# CITY OF SAN ANTONIO

Re: Westlakes P.O.A.D.P.  
File No.: 83-10-57-66  
Revised: 10/29/85

**WESTLAKES  
SIDEWALK PLAN**

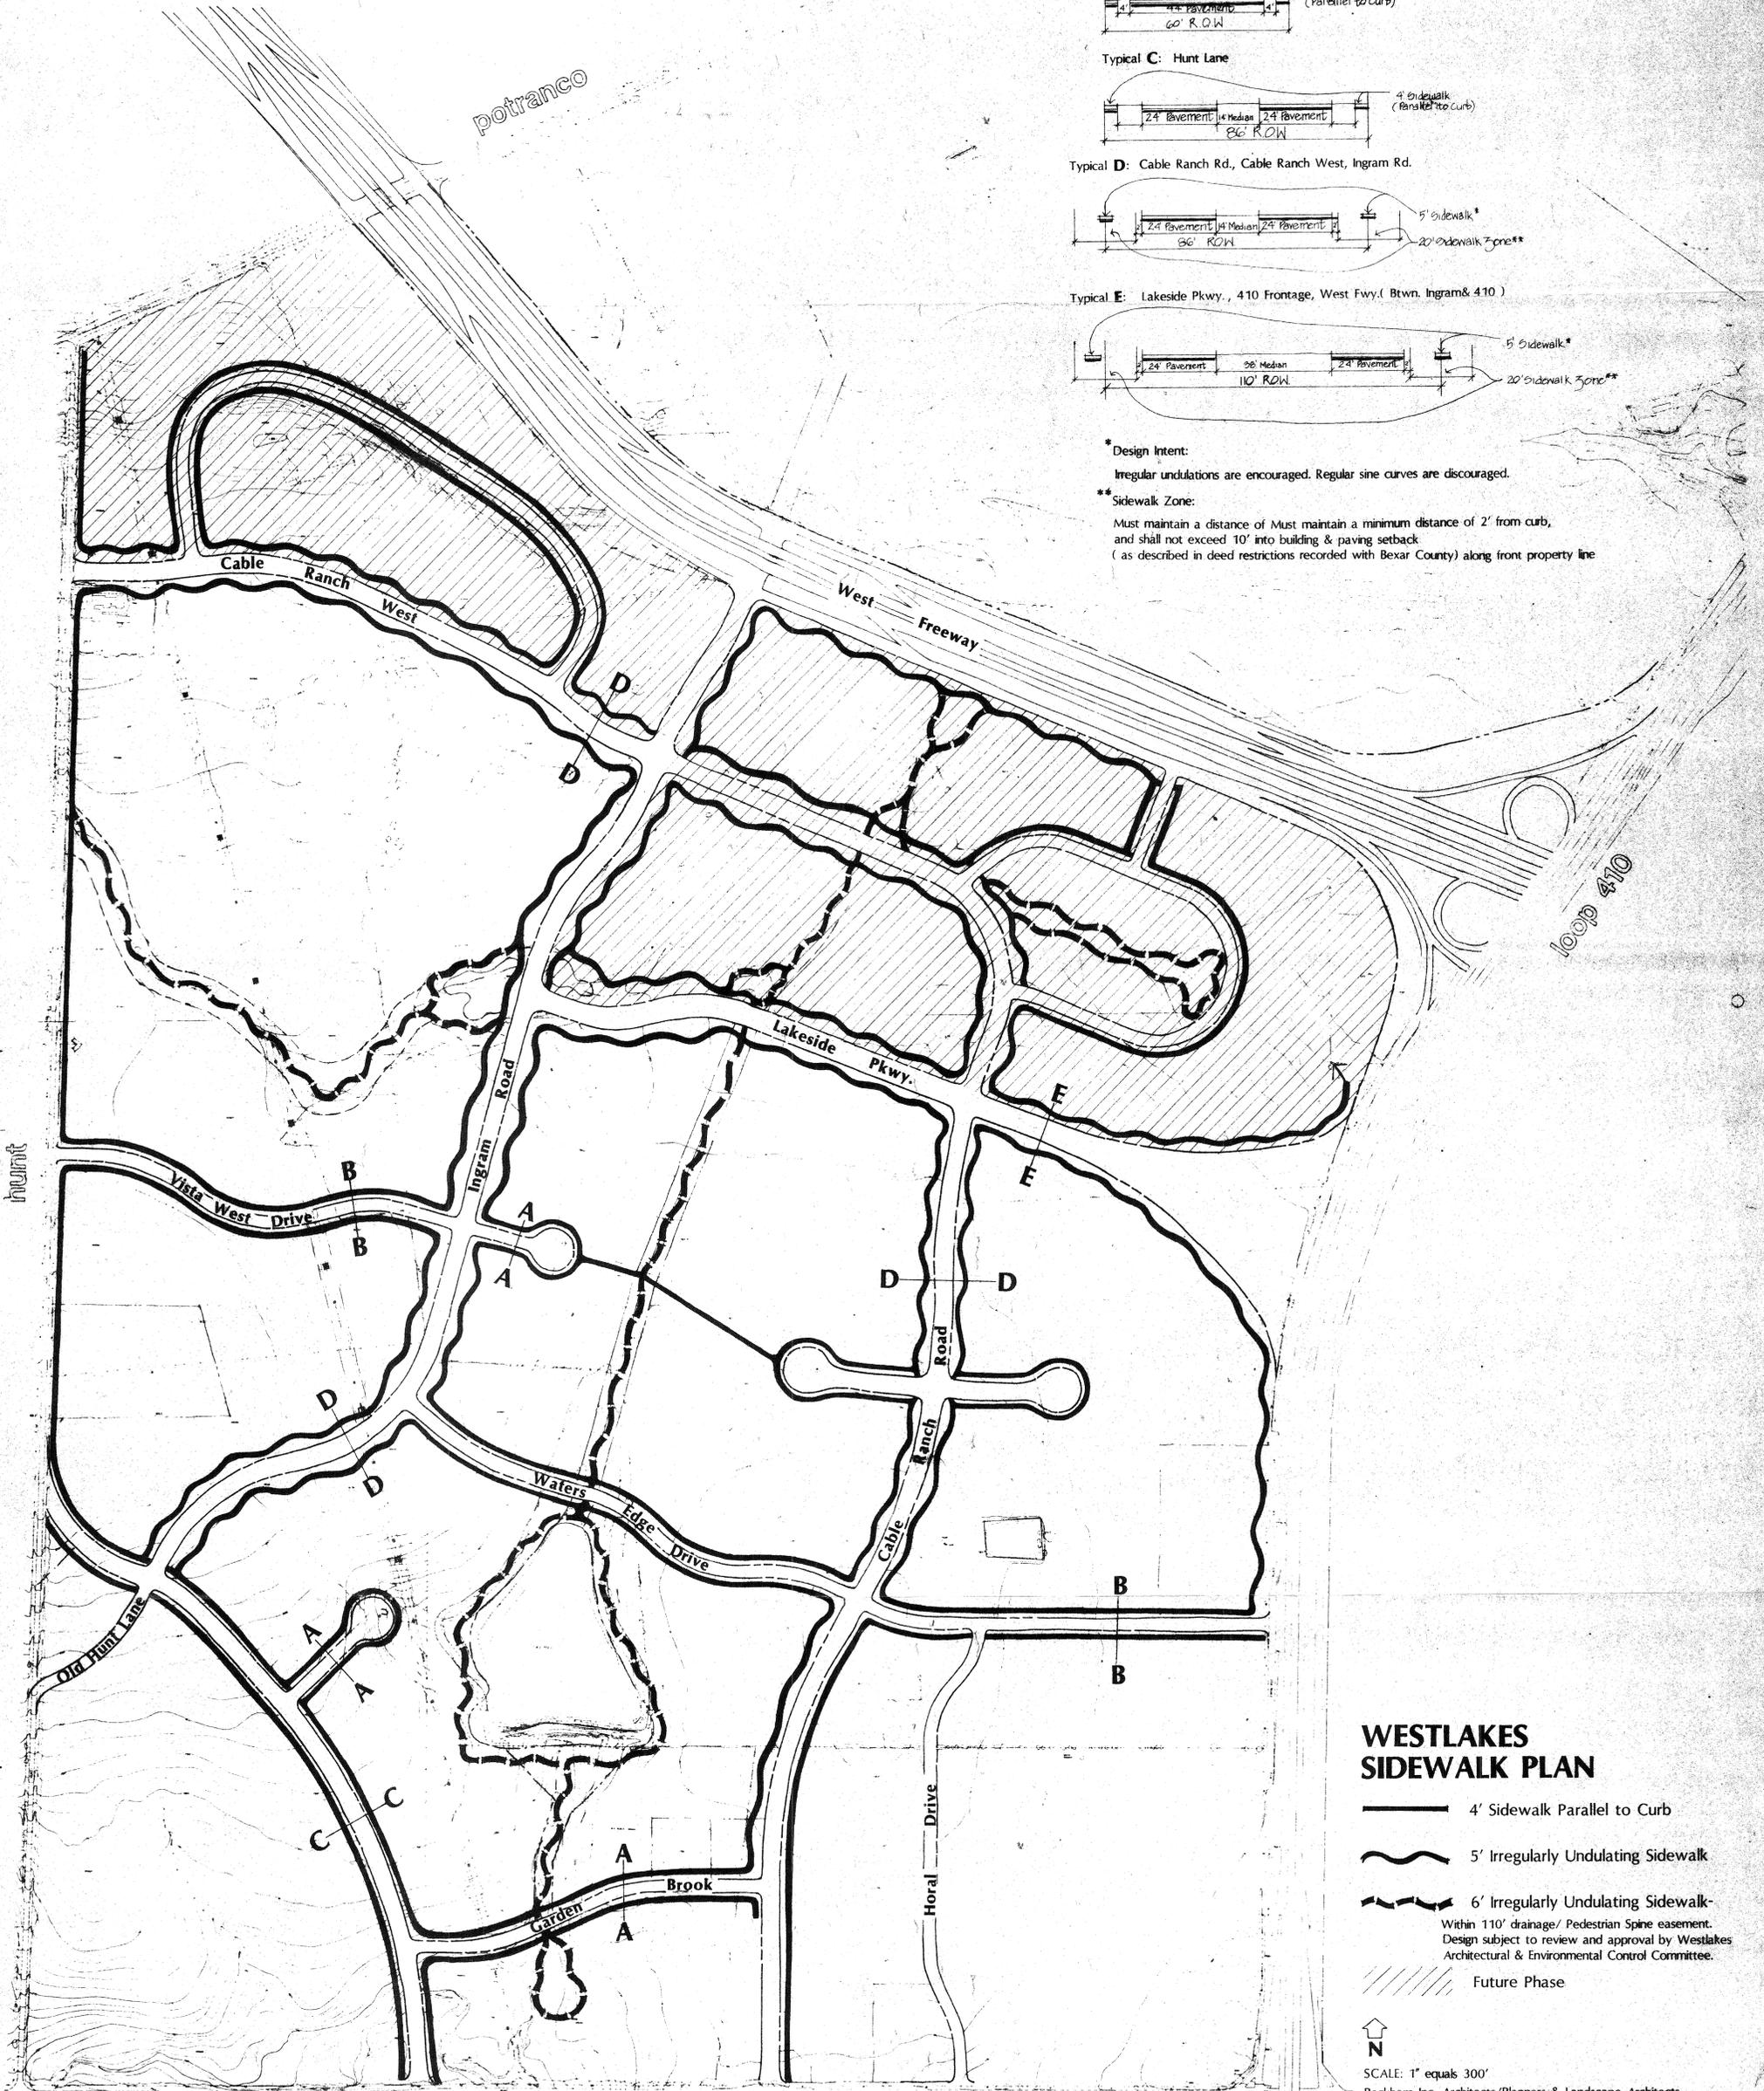
*Need to request pedestrian sidewalk plan via telephone.*

*Note on POAPP that potranco RD is designated on thoroughfare plan. Any platting activity will require ded for full street widening also need to coordinate with Hwy Dept.*
